May 2018
INT FL766-01
NHTSA #18V-191
Transport Canada #18-190
INTERIM RECALL BULLETIN

Subject: Western Star Power Cable Studs

Models Affected: Specific Western Star 4700, 4900, 5700, and 6900 model vehicles manufactured September 12, 2016, through February 6, 2018.

Fig. 3, Installation Inspection

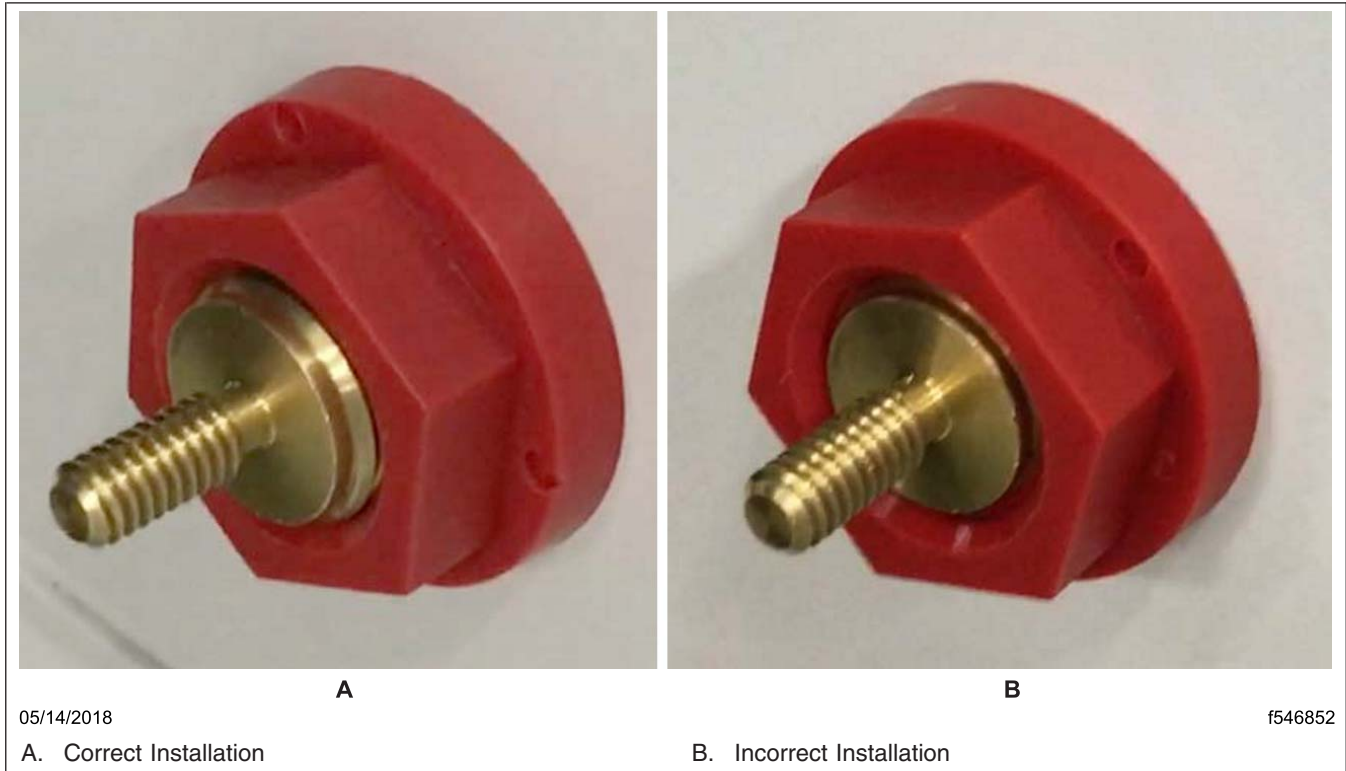
1. Check OWL prior to performing the interim recall to ensure the vehicle is involved and the campaign has not been previously completed. **DO NOT** use a completion sticker for the interim inspection or repair. Attaching a recall completion sticker may prevent the customer from getting the final recall repair.
2. Park the vehicle on a level surface, shut down the engine, and set the parking brake. Chock the tires.
3. Open the hood and locate the three battery bulkhead connectors on the front wall. See [Fig. 1](#).
4. Pull back the covers on the battery bulkhead connectors. See [Fig. 2](#). Inspect the bulkhead studs to make sure at least one thread protrudes past the plastic nut. See [Fig. 3](#) and [Fig. 4](#).

If at least one thread does NOT protrude past the plastic nut, the installation is INCORRECT. Proceed to the next step.

*If at least one thread protrudes past the plastic nut, the installation is CORRECT and the recall is complete. Install the connector covers. **DO NOT** use a completion sticker for the interim inspection or repair. Attaching a recall completion sticker may prevent the customer from getting the final recall repair.*

Fig. 5, Location of Front-Wall Power Terminals (inside the cab)

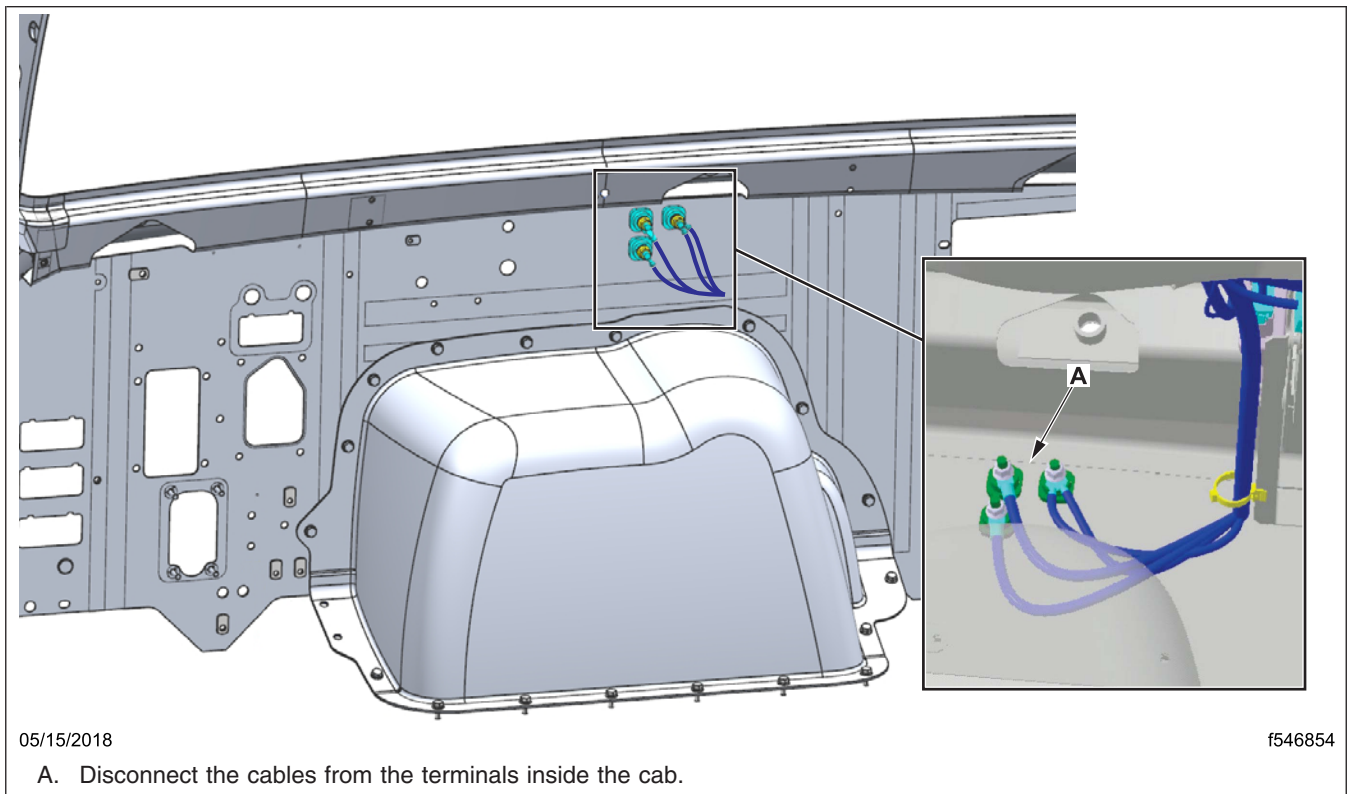
7. Disconnect the cables from the terminals inside the cab. See **Fig. 5**

8. Disconnect the cables from the terminals on the outside of the front wall.
9. Remove the plastic nuts and the studs.
10. Check the gaskets for damage. Replace damaged gaskets.
11. Fully seat the stud in the square hole.
12. Tighten the plastic nut 60 to 84 lbf-in (680 to 950 N-cm). Make sure at least one thread is exposed past the plastic nut.
13. Connect the cables to the terminals on the outside of the front wall.
14. Connect the cables to the terminals inside the cab.
15. Install the dash. Refer to the *Western Star Workshop Manual*, **Section 60.06, Subject 110**.
16. Once the interim repair is complete, **DO NOT** attach a completion sticker. Attaching a completion sticker may prevent the customer from getting the final recall repair.
